AS-BUILT PLAN REVISIONS
BY Roy A. Galli DATE 12-18-89
RCE 16024
ADD LOC DIMS FOR 8 MILE AND
QUASHNICK RD ON 18" S.D. INLET DET.
ADDED SHEETS 28A & 28B

MORADA ESTATES NORTH
SAN JOAQUIN COUNTY

STREET IMPROVEMENT PLANS: MORADA ESTATES NORTH

PLAN AND PROFILE
EIGHT MILE ROAD
LAS POSITAS CIRCLE
MORADA ESTATES NORTH
SAN JOAQUIN COUNTY

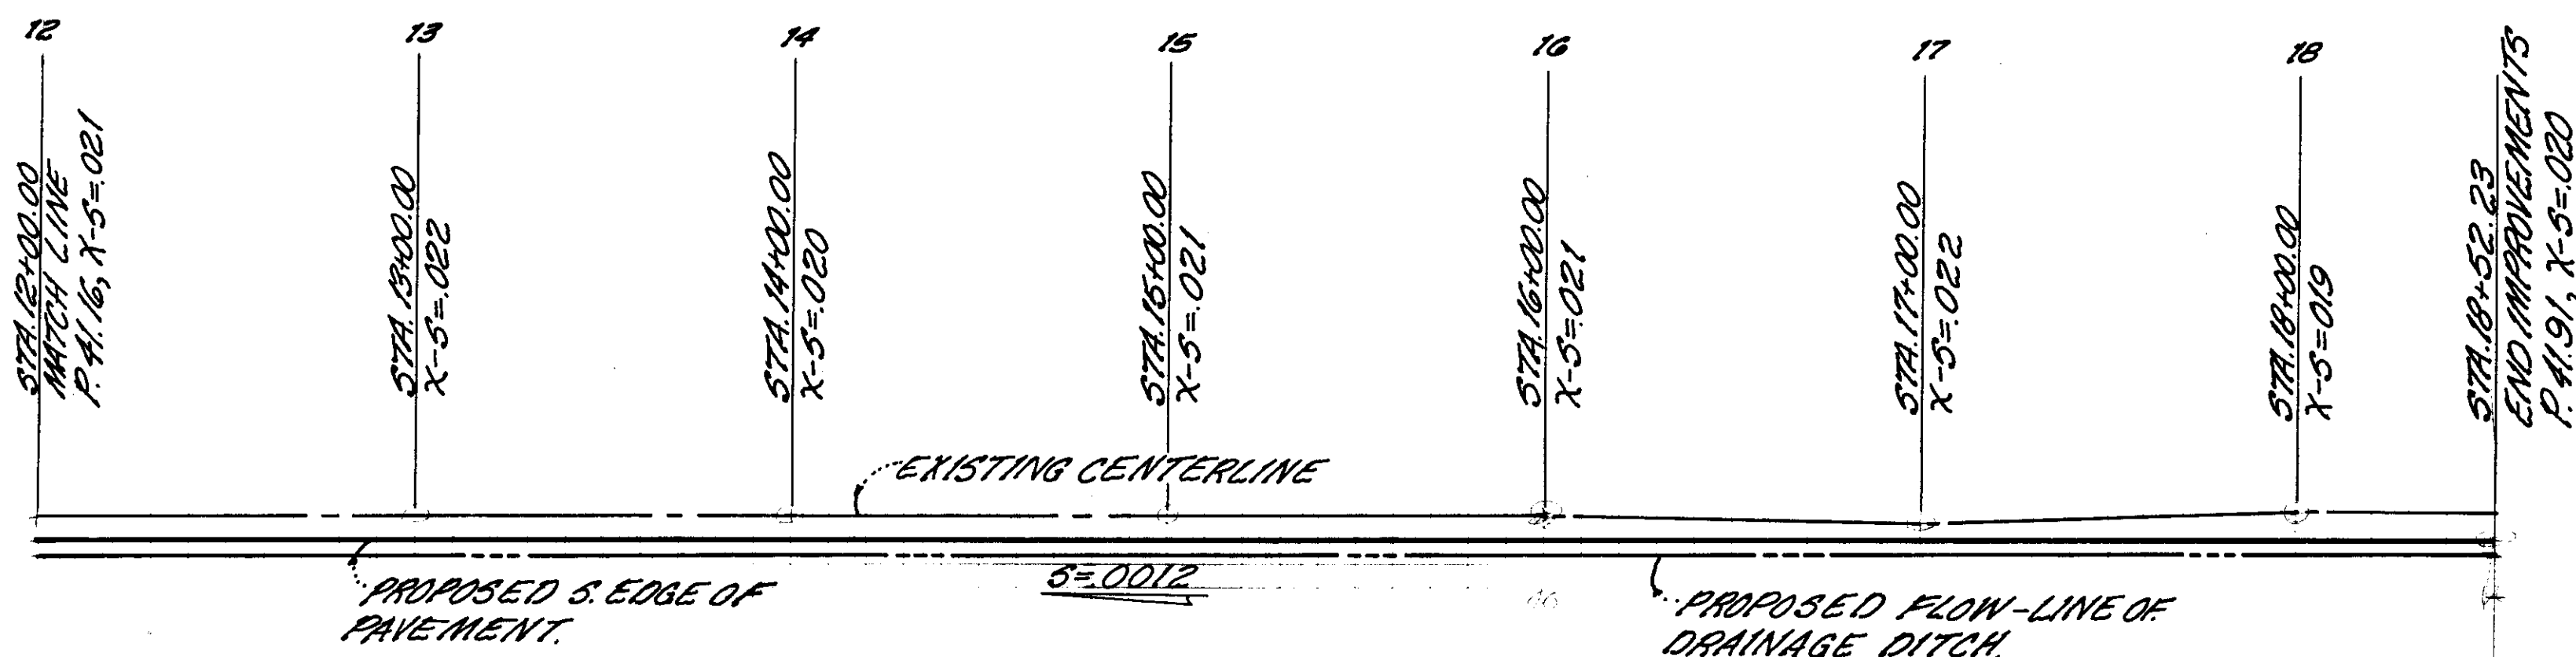
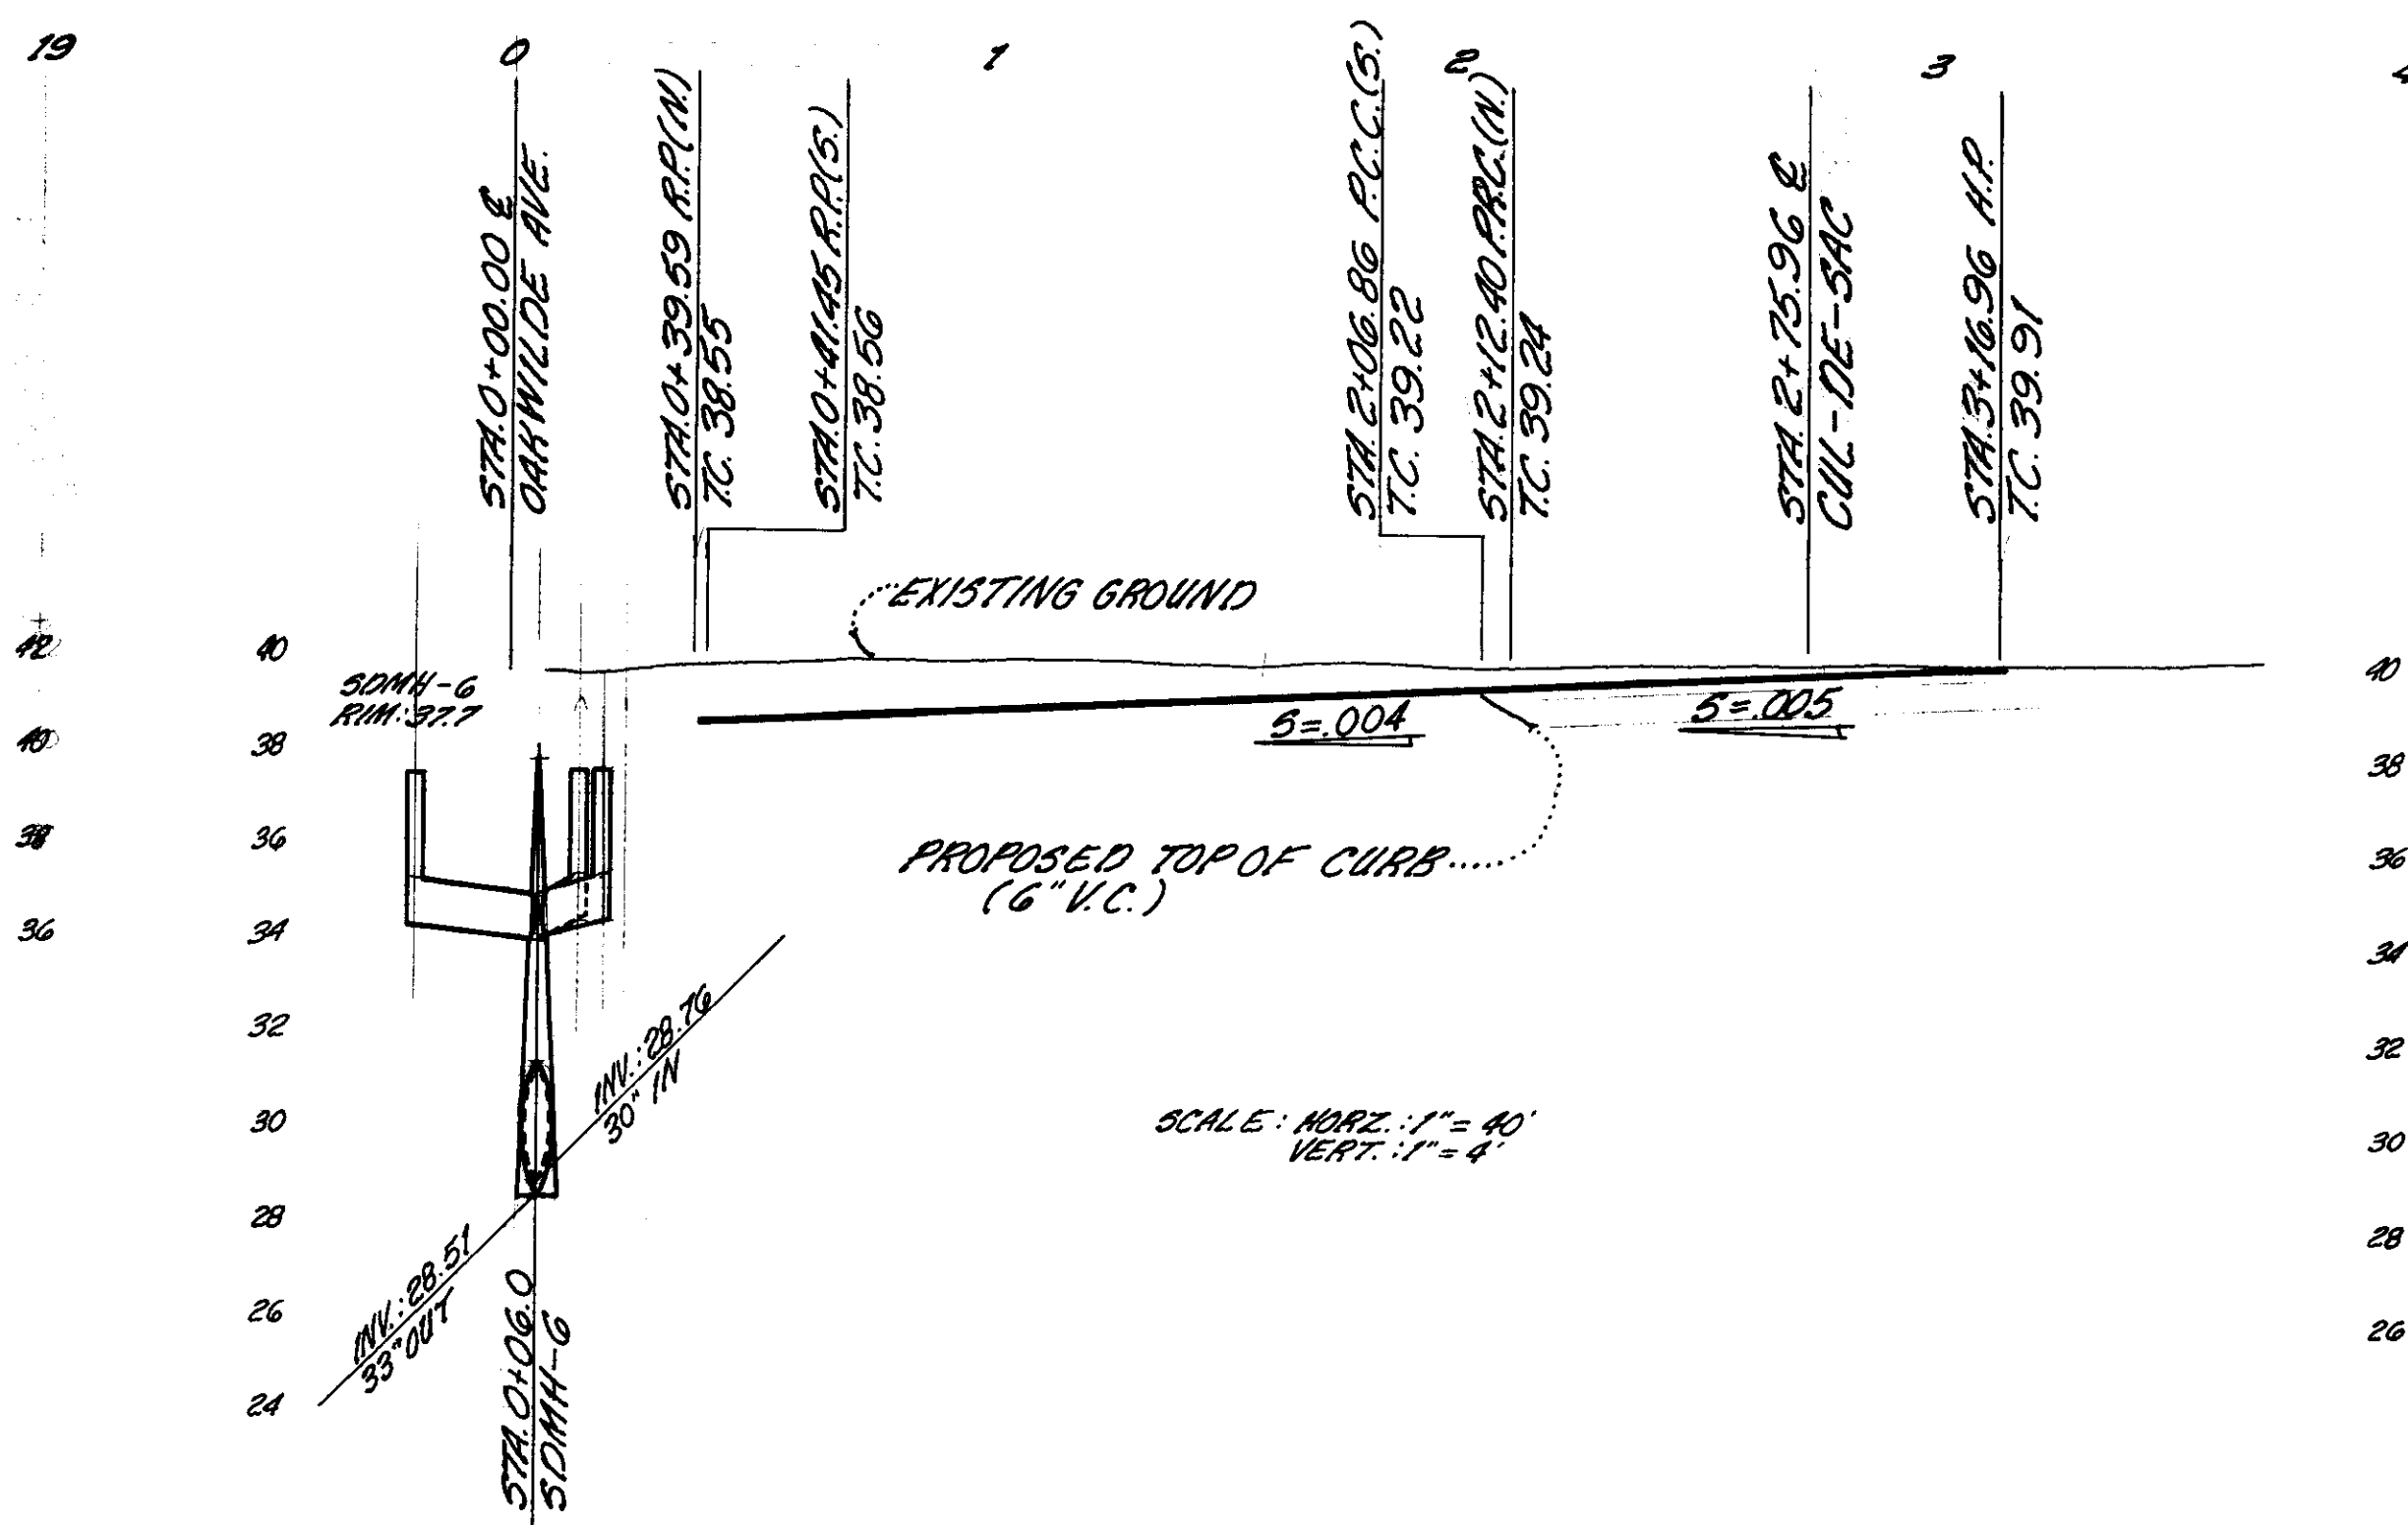
AS-BUILT PLAN REVISIONS	
BY: Roy A. Galli	DATE: 12-18-89
RCE 16024	
ADDED LOT NO'S 22 & 17	
PAVEMENT REMOVAL REDUCTION

WATER PLAN
MORADA ESTATES NORTH
SAN JOAQUIN COUNTY

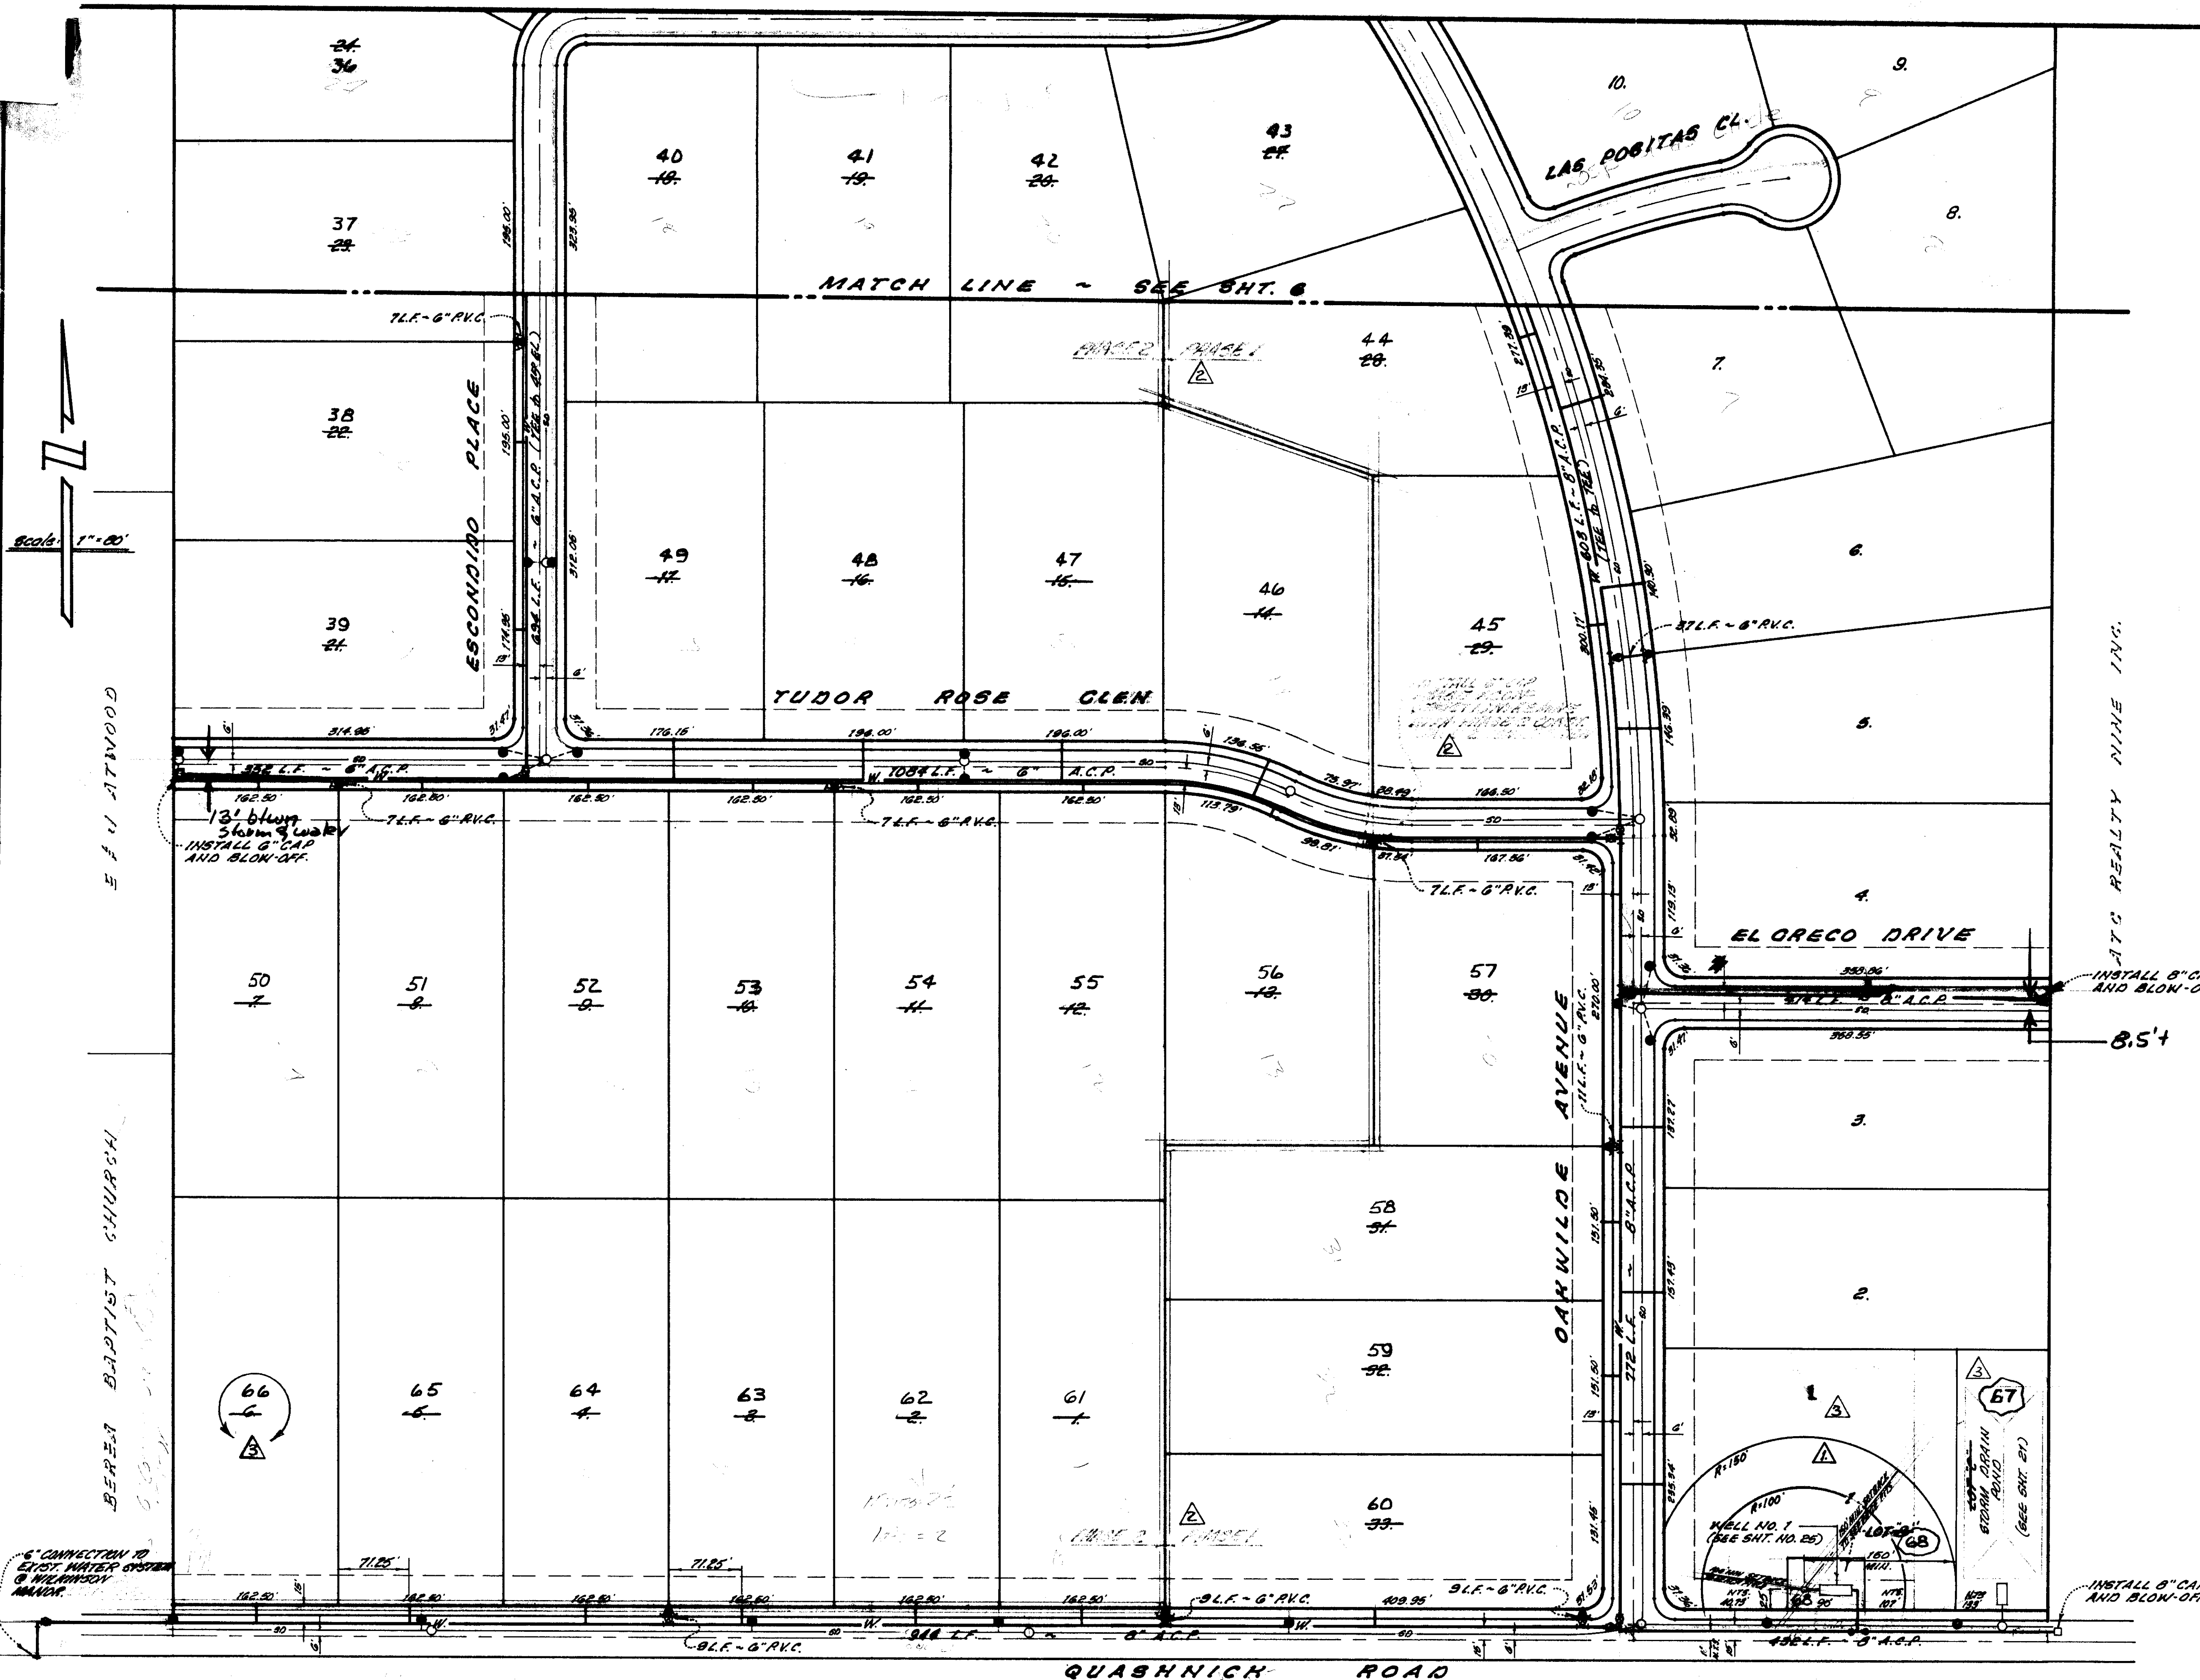
"AS-BUILT" PLAN REVISIONS
BY Tom A. Hall DATE 12-18-89
RCE 16024
REMOVE PHASE LINES & NOTES
REVISE LOT NO'S - ADDED LOT 67 & 68 (WAS 64)
